North Macadam Project: Amendments Report

***Recommended North Macadam Plan
Recommended Zoning Code for North Macadam
Recommended North Macadam Design Guidelines and
Greenway Design Guidelines for North Macadam
(September 10, 2002)***

**City of Portland
Bureau of Planning
October 25, 2002**

Date: October 25, 2002
To: City Council
From: Marie Johnson, *North Macadam Project Leader*
Re: **North Macadam Amendments Report**

Amended River Parkway Alignment

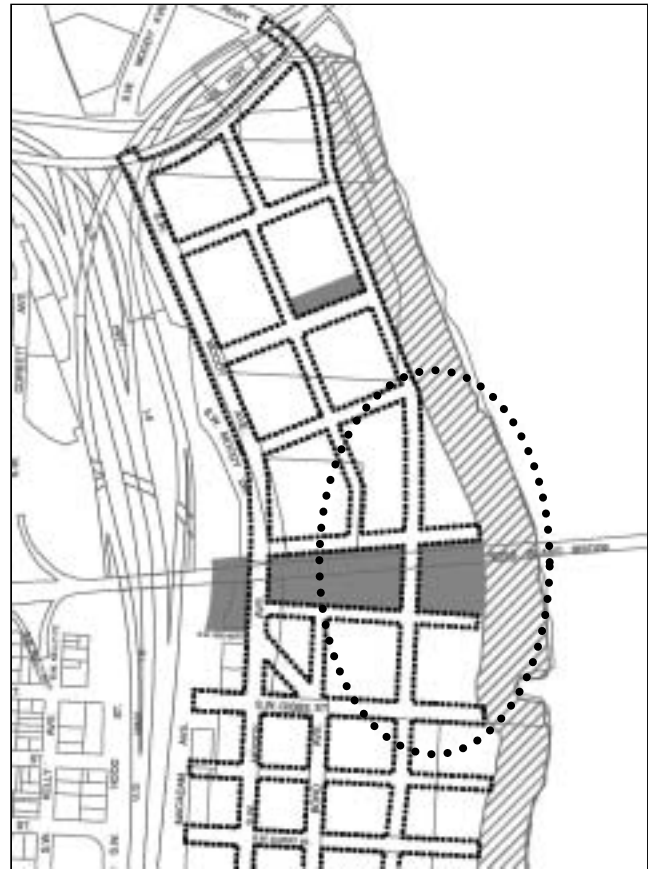
{Amending the Transportation Concept of the North Macadam Plan to reflect an amended River Parkway alignment as shown below implements amendment topic #10}

Map 510-3. Amend height north of Marquam Bridge. (Note: Detailed maps showing changes proposed will be distributed at the hearings.)

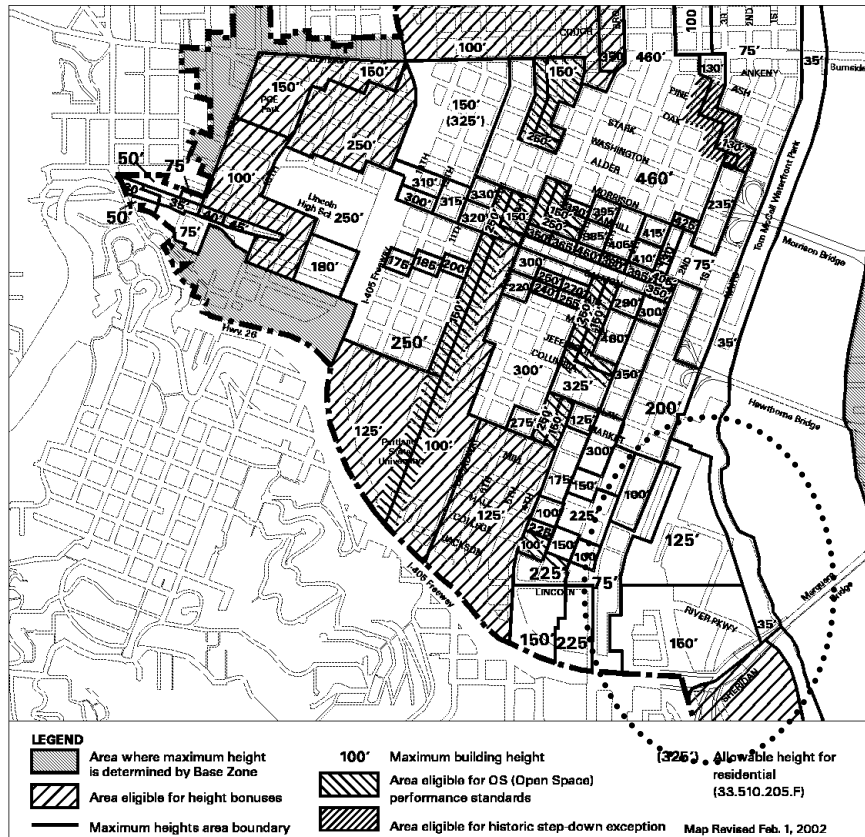
{Amendments to Map 510-3 would implement amendment topic #17.}

Map 510-17. Add new “North Macadam Open Space Height Transfer area” map, shown below:

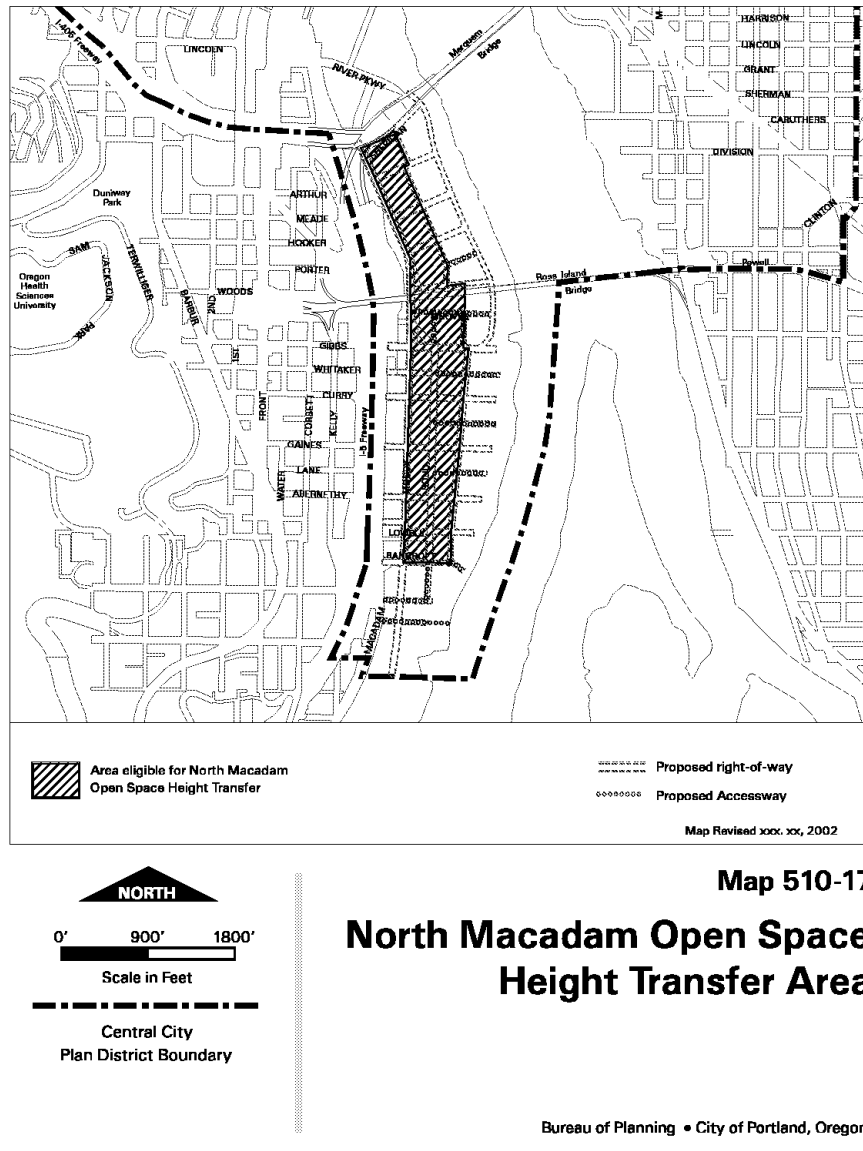
{Adding new Map 510-17 would implement amendment topic #1.}

River Parkway Amendment Concept Drawing

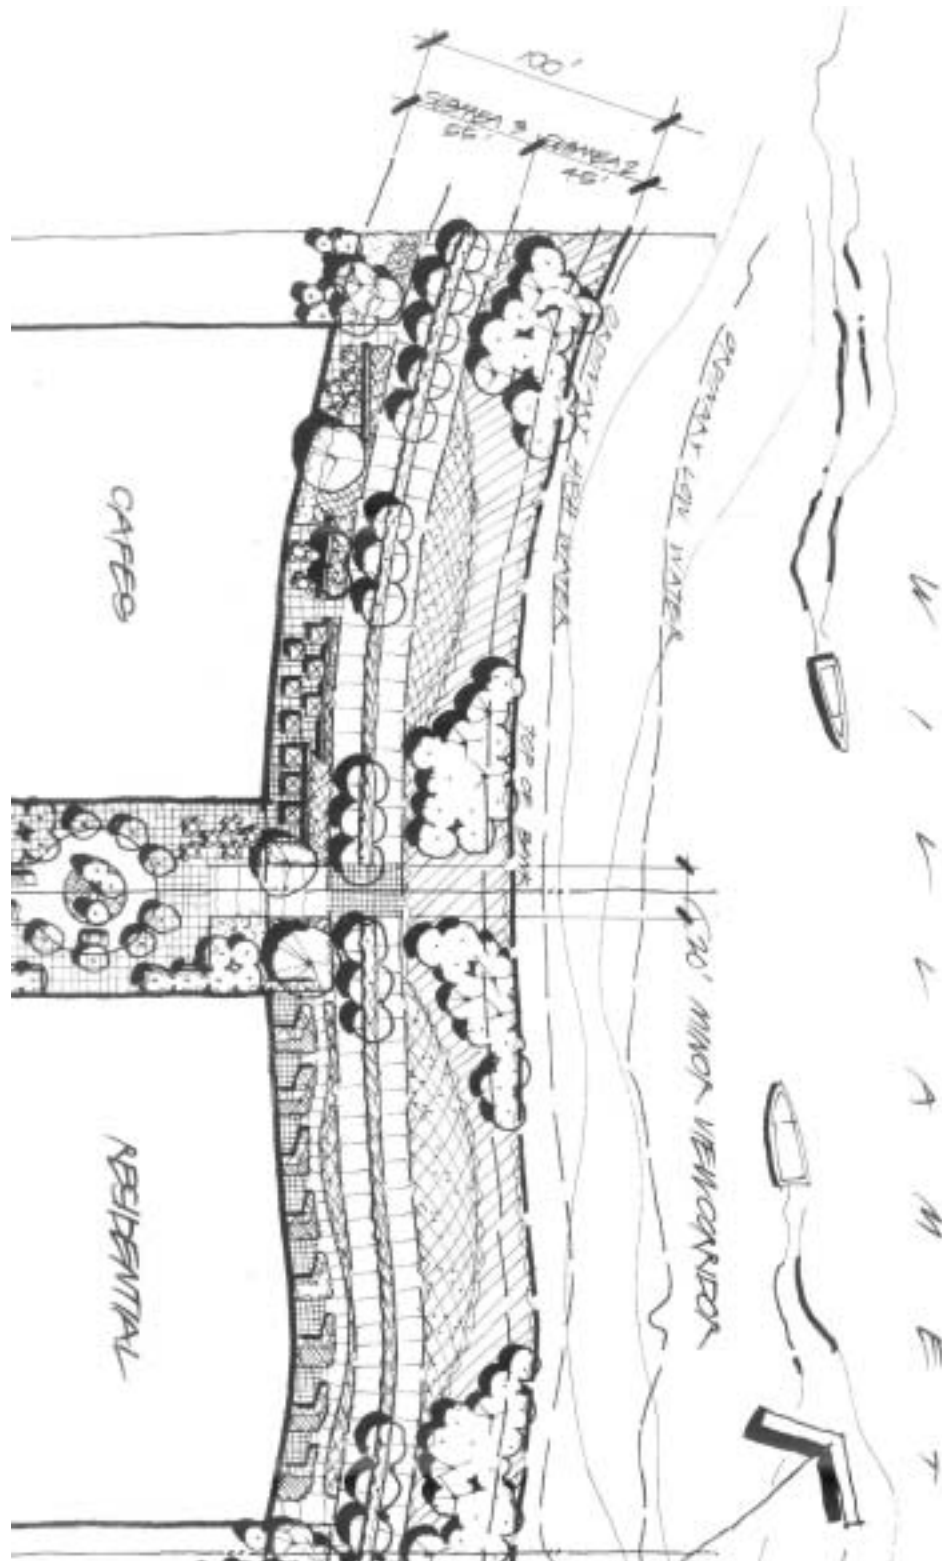
This conceptual drawing of the recommended River Parkway amendment is intended to illustrate some of the possibilities for the street alignment, parcel configurations and greenway development. The amendment is intended to revise the Transportation Concept of the *North Macadam Plan*. The specific elements of the street design will be determined as part of an update to the *North Macadam Street Plan* and conceptual designs for the greenway setback area will be done as part of the *Greenway Design Coordination Plan*. For a more detailed description of the amendment request and its rationale, please see amendment request #10 of the Amendments Report.

Site Map for North of Marquam Bridge Amendment

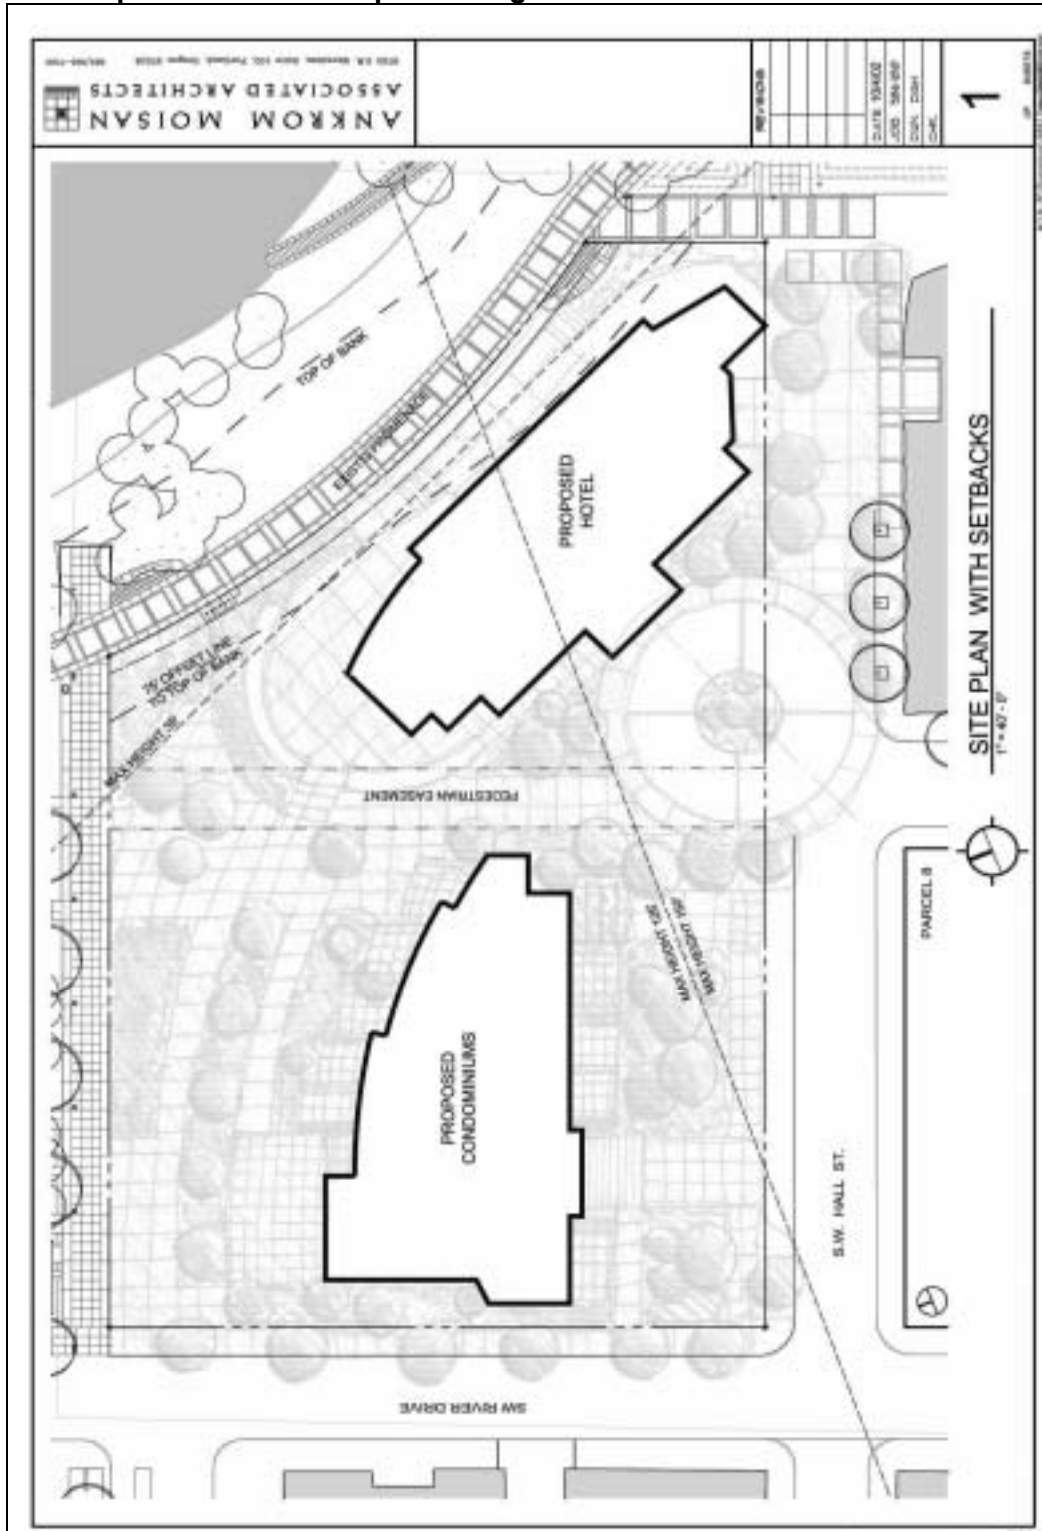
This map shows the site plan layout for a proposed hotel and condominium development for the area north of the Marquam Bridge with a request for height changes as part of the *North Macadam Plan*. The map indicates the maximum heights allowed under the existing Zoning Code. The requested height changes are described in the "Discussion" section of the *Amendments Report*.
